PHAP12-00012

Date:	June 11, 2012
Application Type:	Certificate of Appropriateness
Property Owner:	Maria L. Yee and Robert Concha
Representative:	Jesus Diaz
Legal Description:	Lots 9 and 10, Block 11, Mundy Heights Addition, City of El Paso, El Paso County, Texas
Historic District:	Sunset Heights
Location:	1316 Missouri
Representative District:	#8
Existing Zoning:	C-2/H (Commercial/Historic)
Year Built:	N/A
Historic Status:	N/A
Request:	Certificate of appropriateness for the construction of a two story duplex.
Application Filed:	5/22/2012
45 Day Expiration:	7/6/2012

The construction of a two story duplex.

1 SITE PLAN

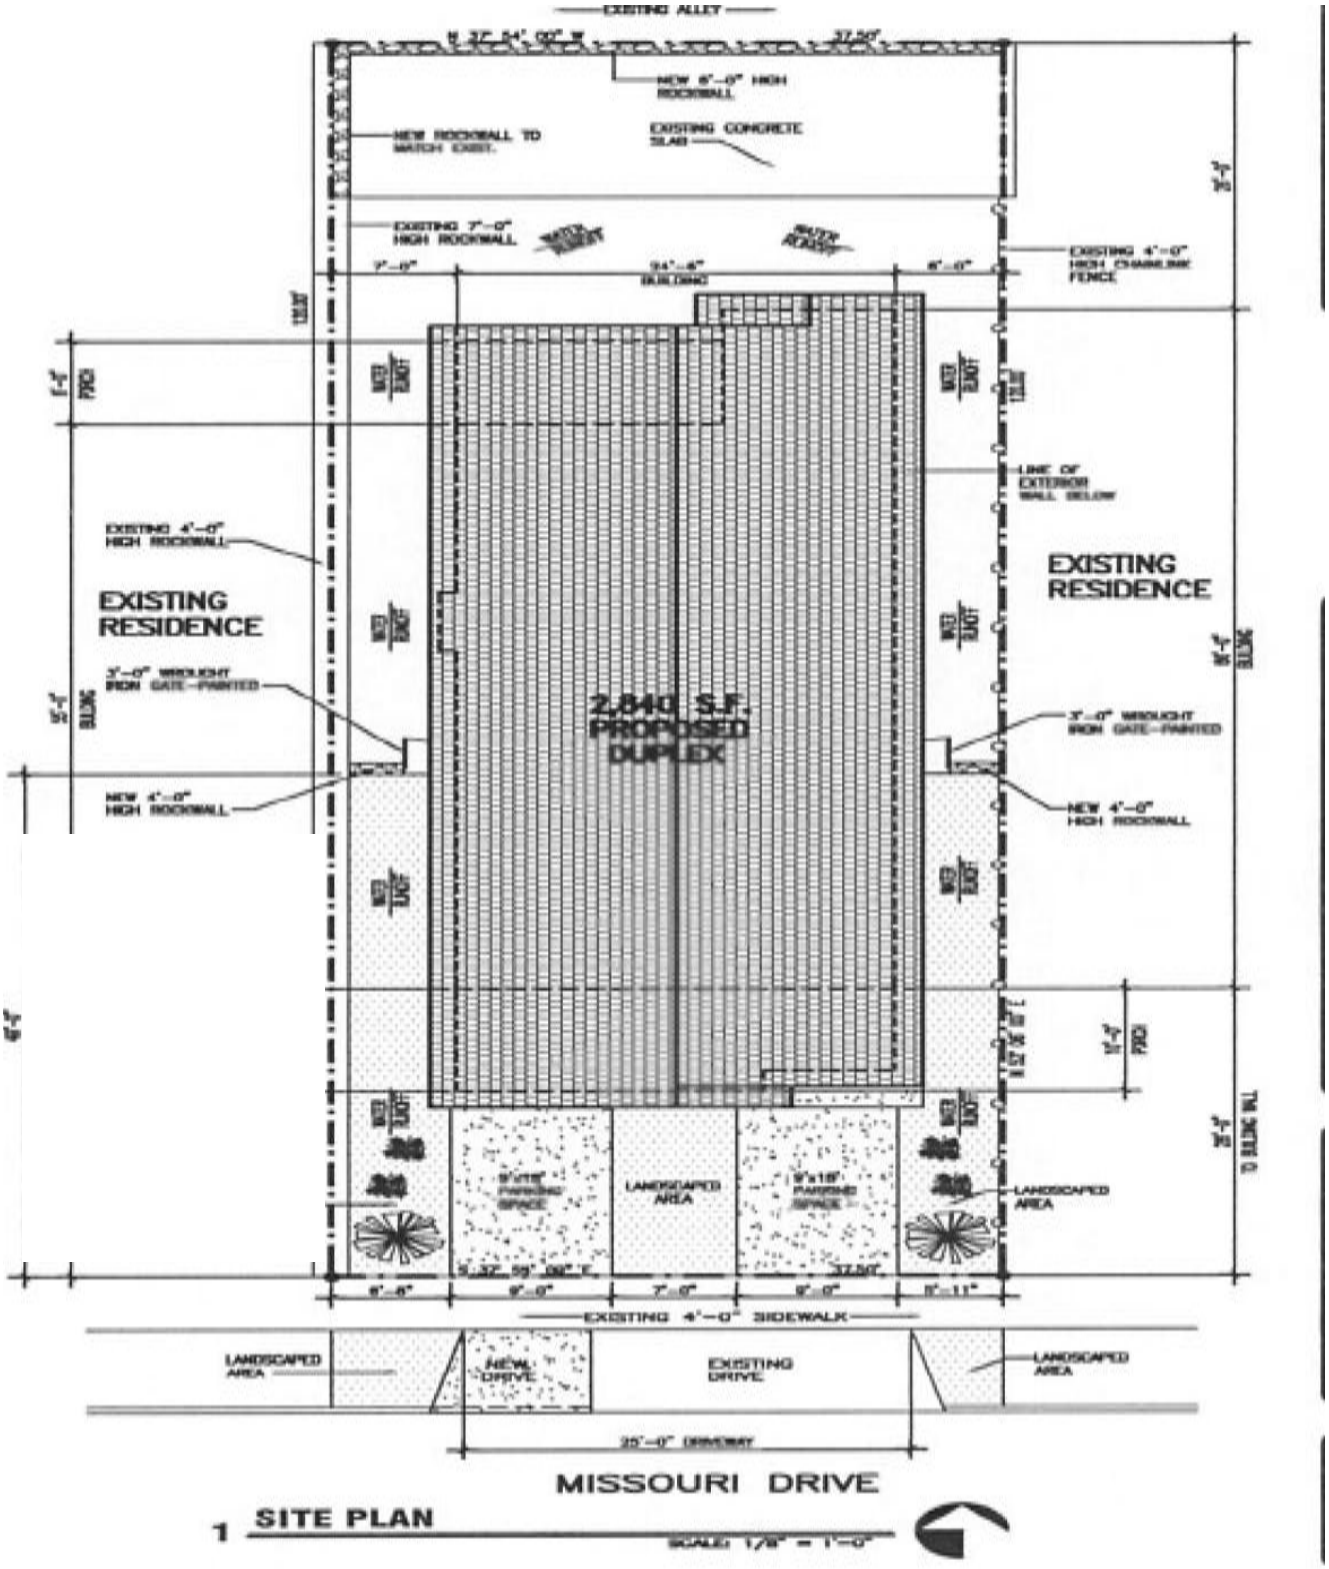
The modifications are that the parking spaces at the front of the main facade be eliminated and that the new building be constructed in line with the adjacent buildings, the eaves be extended outward up to two feet, and the window surrounds on the main façade will be replaced with sills.

We didn't see any dumpster on the site plan but with only 2 apt units, we imagine they can use trash cans instead of placing dumpsters in front of the house.

4 FRONT EXTERIOR ELEVATION
SCALE: 1/4" = 1'-0"

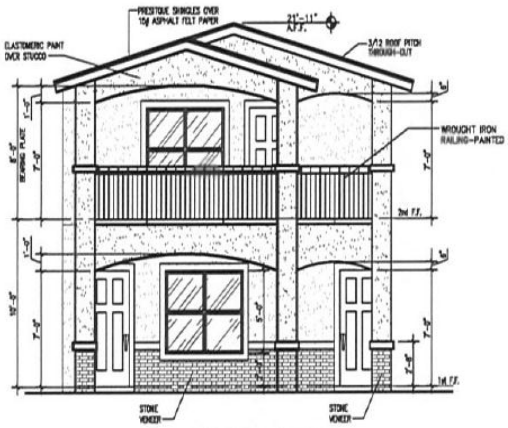
1. Roof pitch should be no less than 4/12 to match surrounding houses.
2. Arch radii on the porch opening tops should match those found on the property across the street.
3. First floor picture window should be completely above the stone veneer.
4. Need cut sheets for:
- Roof shingles color
-Exterior color pallet color
-Stone veneer
-Wrought iron pattern

We noticed the plans had an architect stamp and it made us think: If the architect could properly incorporate some longer strong roofline eaves (see photo) instead of the usual anemic East-side-of-EP eaves, it'd do wonders in conforming to the neighborhood.
